ARCHITECTURAL REVIEW BOARD MUNICIPAL PLANNING COMMISSION -AGENDA-

Thursday, January 12, 2023 at 7:00 P.M.

MEMORANDUM

SUBJECT: Staff Memo for the Meeting of January 12, 2023

VEHICULAR CIRCULATION - BUS DROP OFF

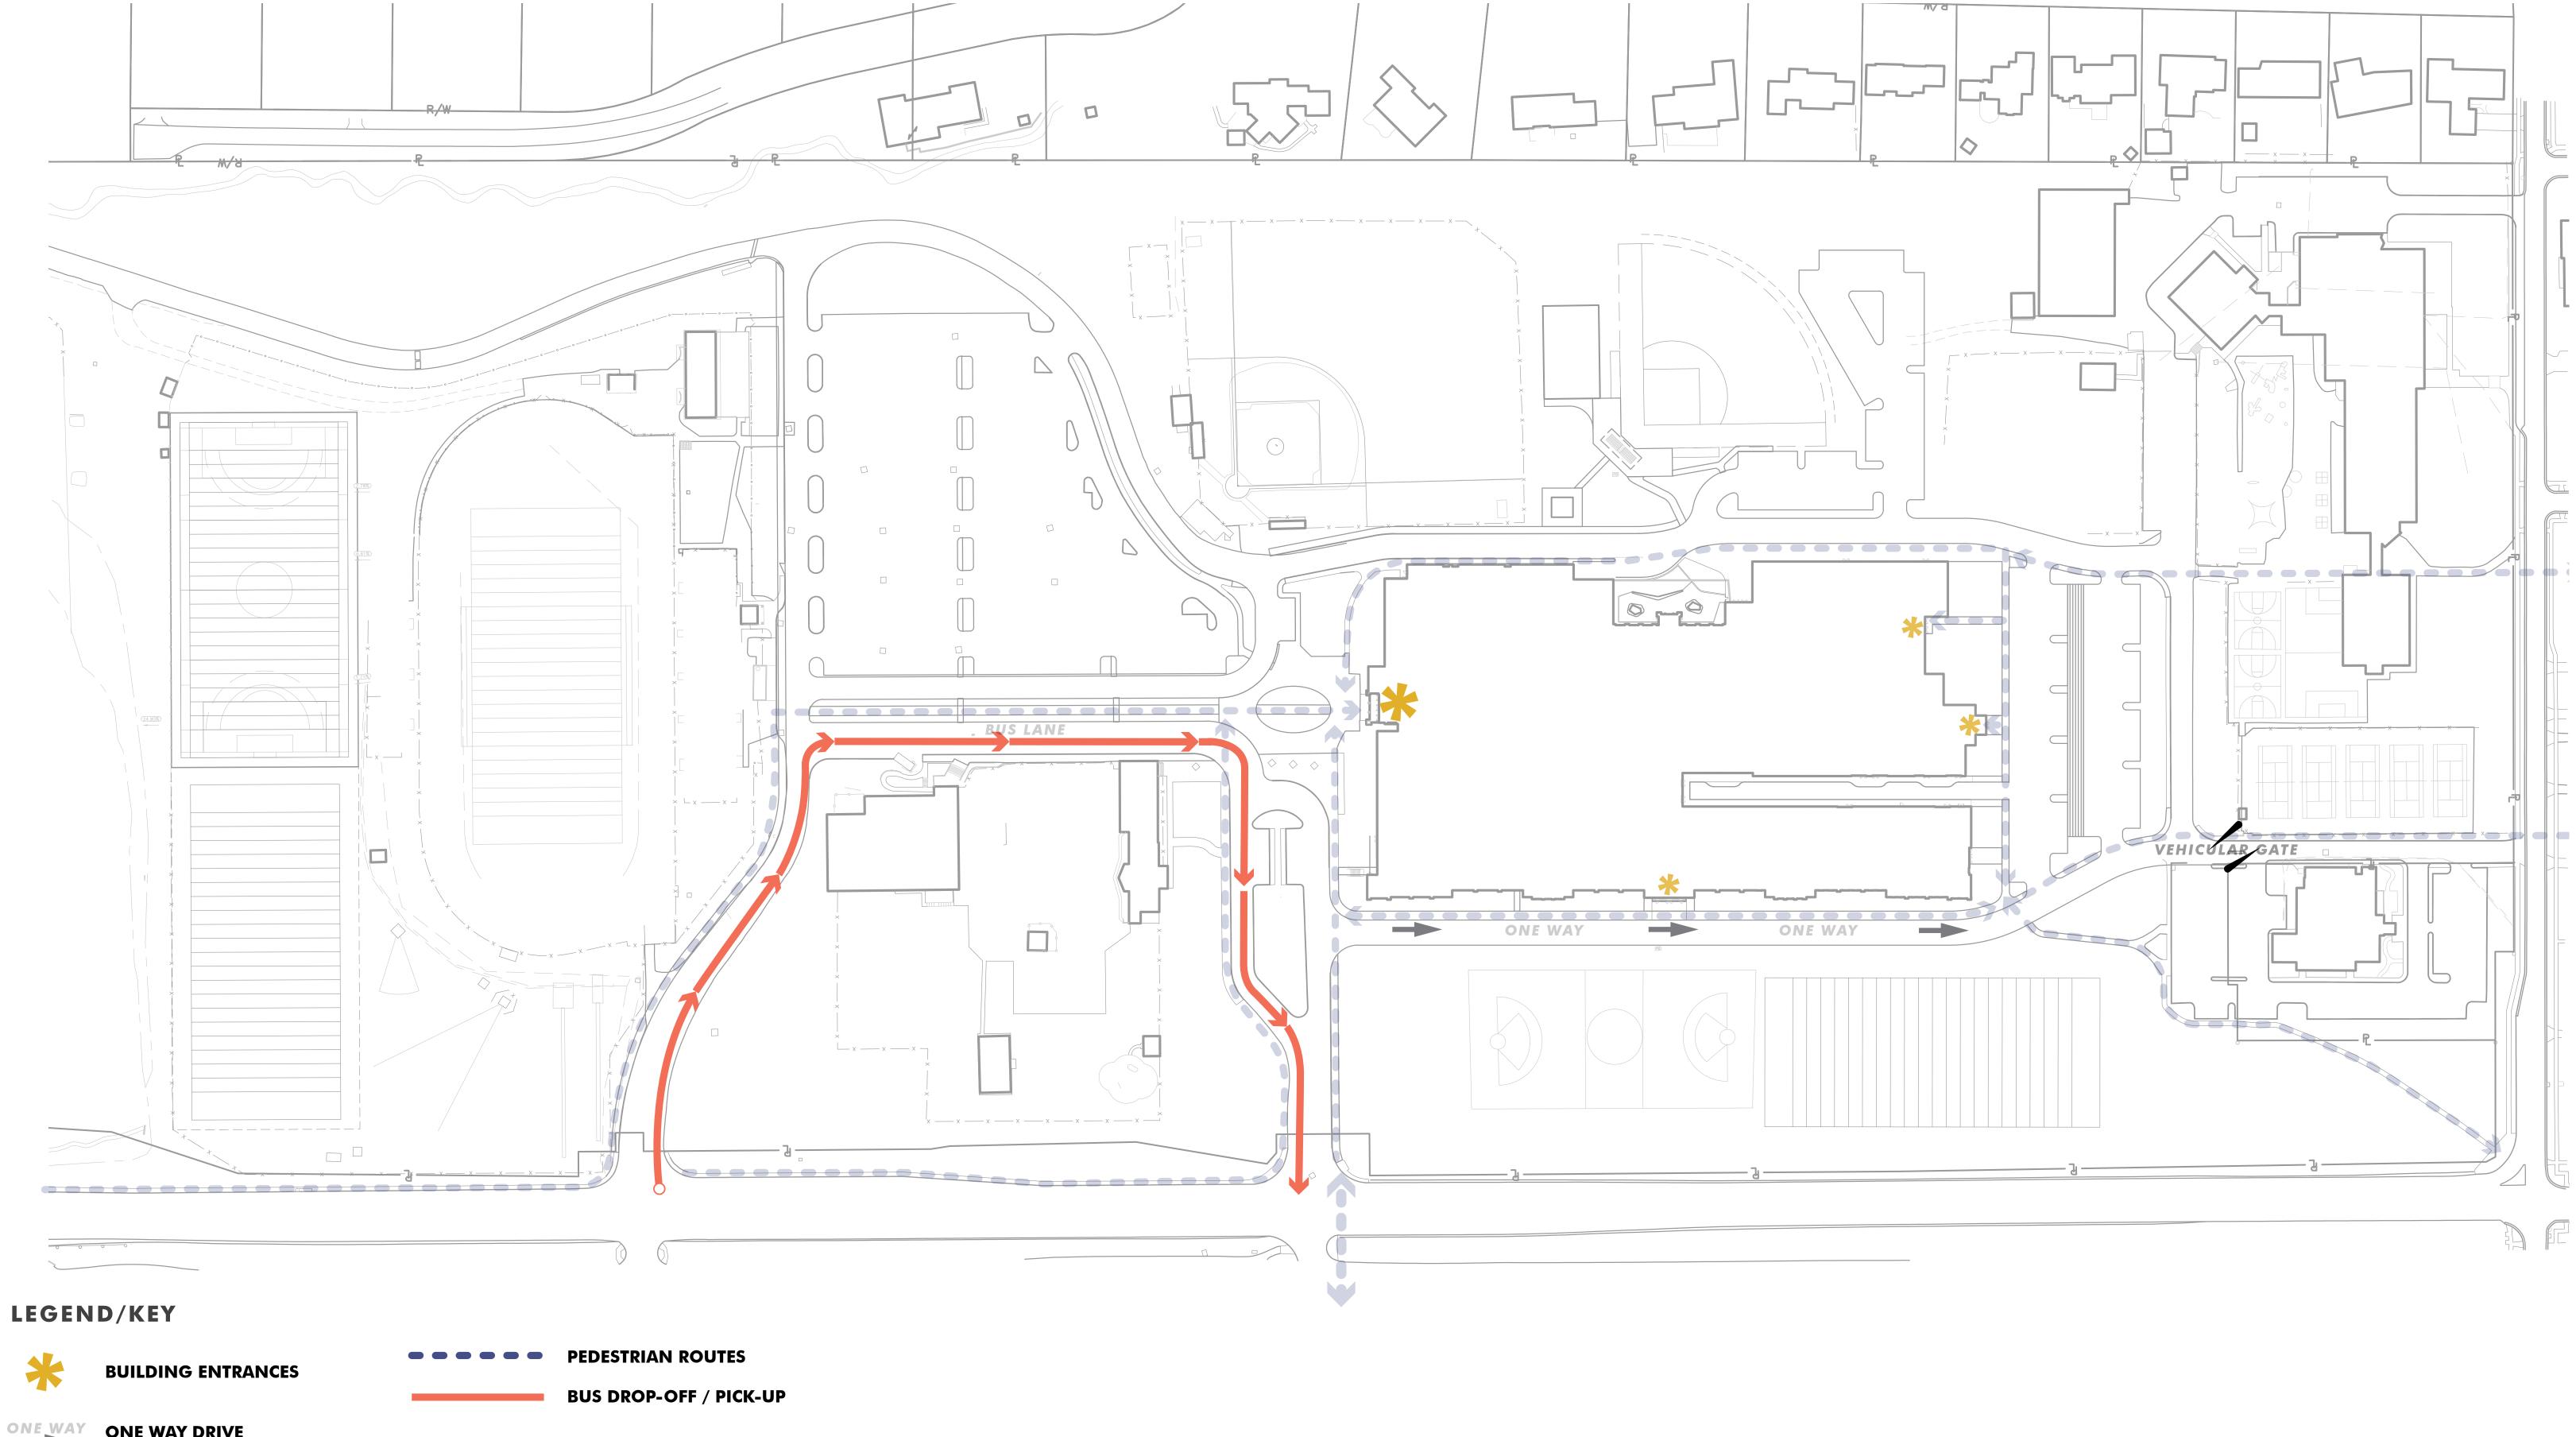
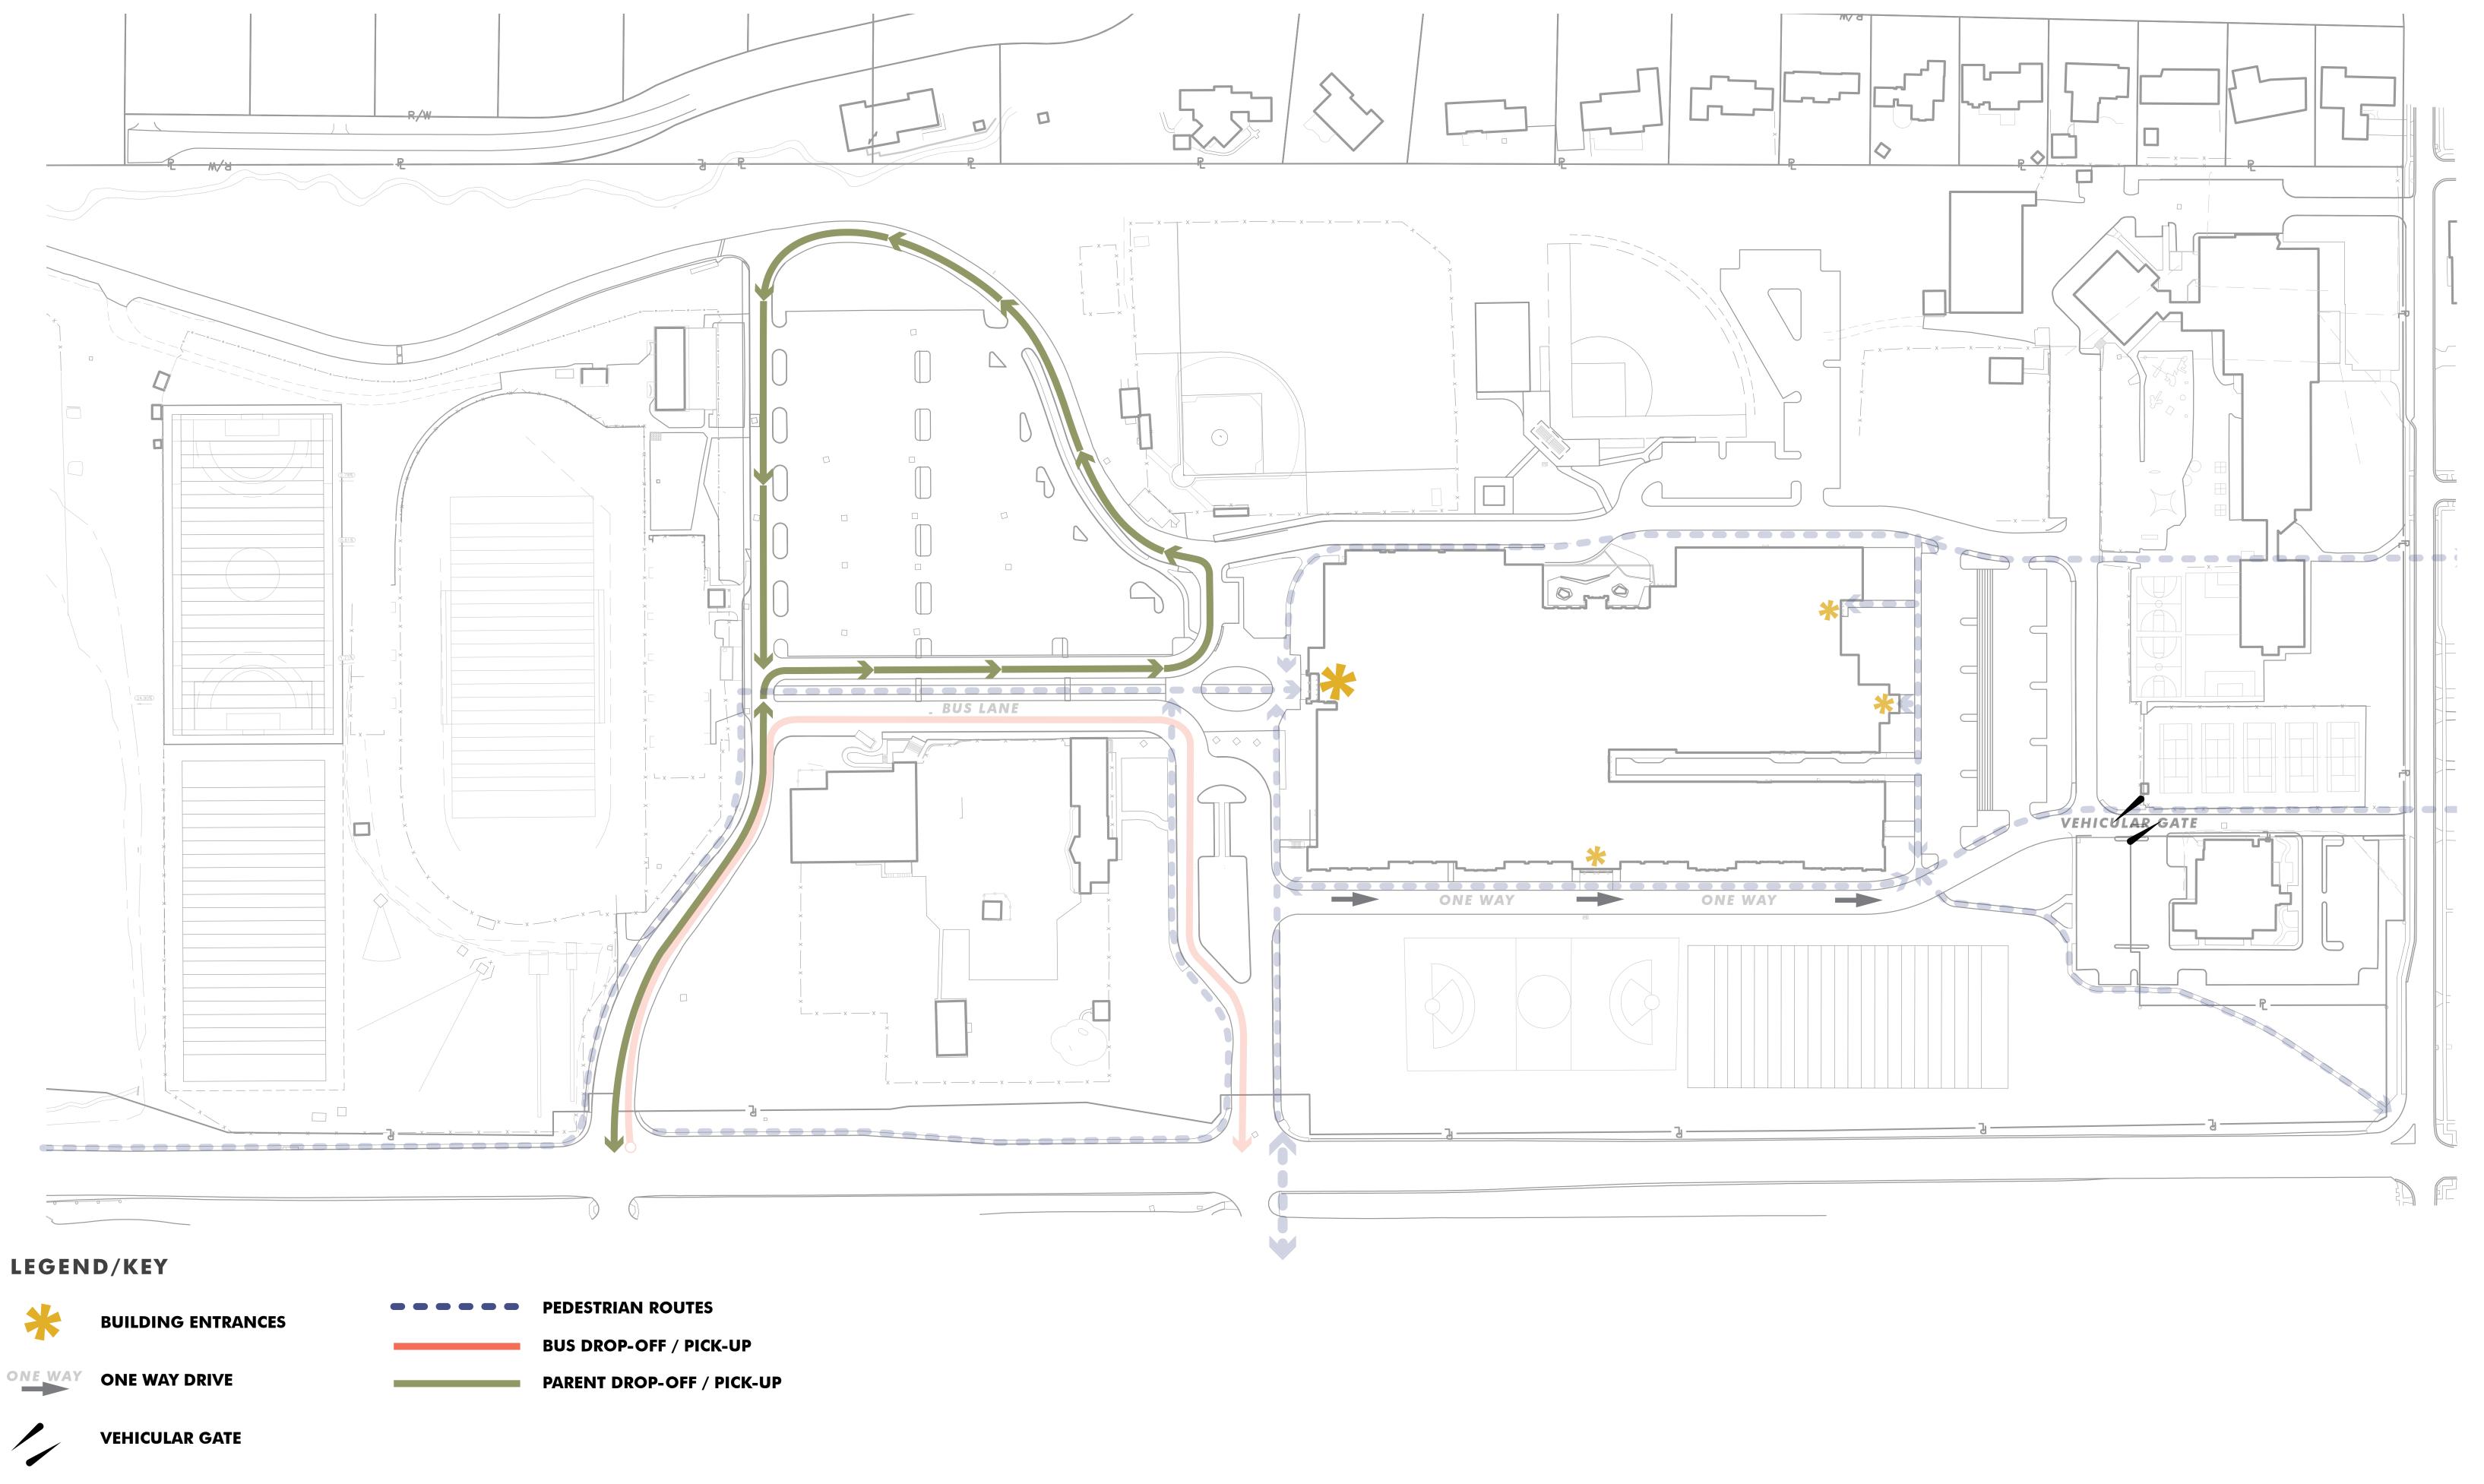
- 3. The only designated circulation to the site's Evening Street access point is visitor vehicles. Discussions with staff indicated that this access point would have broader use. Clarify the use of this access point and the operation of the vehicular gate.
